# UNITED STATES PATENT AND TRADEMARK OFFICE

APPLICATION NO.	FILING DATE	FIRST NAMED INVENTOR	ATTORNEY DOCKET NO.	CONFIRMATION NO.
10/555,156	11/02/2005	Naoki Fujiwara	14321.81	3941
22913	7590	08/23/2007		
WORKMAN NYDEGGER 60 EAST SOUTH TEMPLE 1000 EAGLE GATE TOWER SALT LAKE CITY, UT 84111			EXAMINER PARK, KINAM	
			ART UNIT 2828	PAPER NUMBER
			MAIL DATE 08/23/2007	DELIVERY MODE PAPER

<b>Office Action Summary</b>	Application No. 10/555,156	Applicant(s) FUJIWARA ET AL.	
	Examiner Kinam Park	Art Unit 2828

**DETAILED ACTION**

**Fig. 1. Schematic structure of the mode-hop-free DBR laser.**

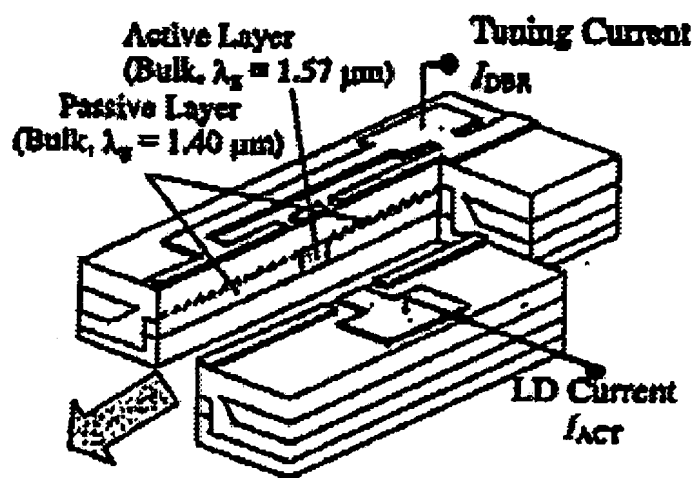
Fujiwara et al. discloses in figure 1 and specification:

12. A wavelength tunable distributed Bragg reflector (DBR) laser having optical waveguide surrounded by a clad layer on a substrate, comprising;

a first passive region optical waveguide (see, Passive Layer) including a first DBR region having a diffraction grating in a section whose length corresponds to effective length of 95% or more in a saturated effective length value (see, figure 3 & 4), wherein the lasing wavelength is controlled by a DBR control current (see,  $I_{DBR}$ ),

a second passive region optical waveguide (see, Passive Layer) including a second DBR region having a diffraction grating in a section whose length is shorter than the first DBR region (see, figure 3 & 4), wherein the lasing wavelength is controlled by the DBR control current (see,  $I_{DBR}$ ), and

an active region optical waveguide (see, Active Layer) in which the first passive region optical waveguide and the second passive region optical waveguide are optically connected at both ends, wherein emission state is controlled by the active region current (see,  $I_{ACT}$ ), irrespective of the DBR control current.

Regarding claim 13-15, 17-19, 21, 23, 25-26, 28, 30-32, 34, 36-38, 40, Note that Fujiwara et al. discloses in figure 1 and specification a first electrical isolating region and a second electrical isolating region (see, the separation of electrode) (**claim 13, 30, 36**), the length of active region in a range from  $30 \mu\text{m}$  to  $100 \mu\text{m}$  (see, figure 5) (**claim 15, 17-18, 21, 23, 25-26, 31-32, 37-38**). The effective length of the second DBR region of 75% or less (**claim 14, 19**) in the saturated effective length value and the ratio of the lasing wavelength shift quantity to the Bragg wavelength shift quantity in a range from 0.9 to 1.1 (**claim 28, 34, 40**) are insignificant in this art since these can be controlled by coupling coefficient of corrugation grating and the length of DBR gating (see, figure 3 & 4).

**Fig. 12. Structure of the 4-ch mode-hop-free DBR laser array.**

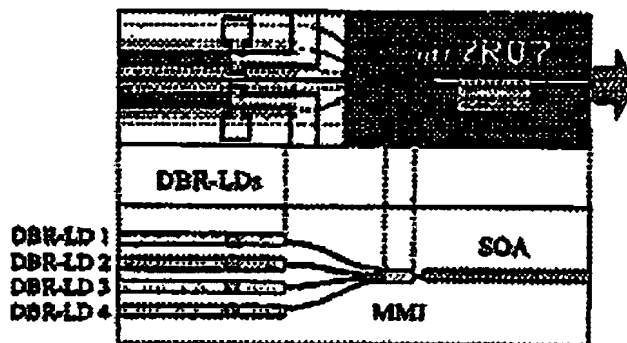
Fujiwara et al. also discloses in figure 12, an optical coupler (see, MMI) and an optical semiconductor amplifier (see, SOA).

However, Fujiwara et al. is silent as to the plurality of wavelength tunable DBR laser having different pitches of the diffraction grating.

Ikeda et al. discloses the diffraction grating with different grating (see, col.1, lines 15-22).

Therefore, it would have been obvious to a person of ordinary skill in the art at the time of invention to combine the diffraction grating with different grating of Ikeda et al. with a wavelength tunable DBR laser of Fujiwara et al because this provides a plurality of laser light beams having different wavelengths (see, col.1, lines 15-22 of Ikeda et al.).
